City of Santa Fe, New Mexico

memo

2025-011550-HDRB. 539 Garcia St. Downtown & Eastside Historic District. Contributing. Geisler Projects, agent for Matt and Penelope Rembe, owners, proposes to construct a 108 sq. ft. addition to a height of 10'-6", where the maximum allowable is 10'-10". A 206 sq. ft. portal to a height of 10'-3". Replace windows and doors on the residence, convert the garage to a casita by altering the garage door to a window, and installing a new window, and reroof, and stucco both buildings. An exception is requested to section 14-5.2(D)(2)(d) for constructing an addition within 10'-0" of the primary façade.

Figure 5: Façade Diagram

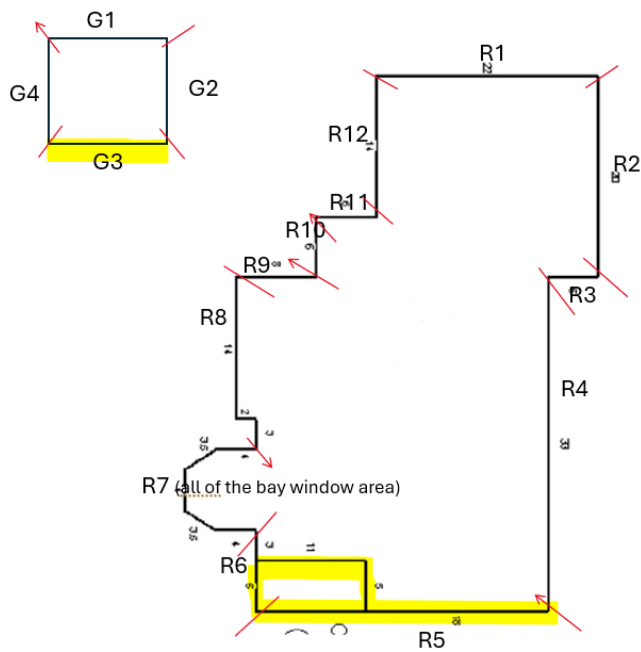
Under case 2025-010489-HDRB on June 24, 2025, the HDRB retained the main residence as contributing and designated the south facade as primary, and designated the garage as contributing with the south facade as primary, excluding the non-historic materials and the garage door material.
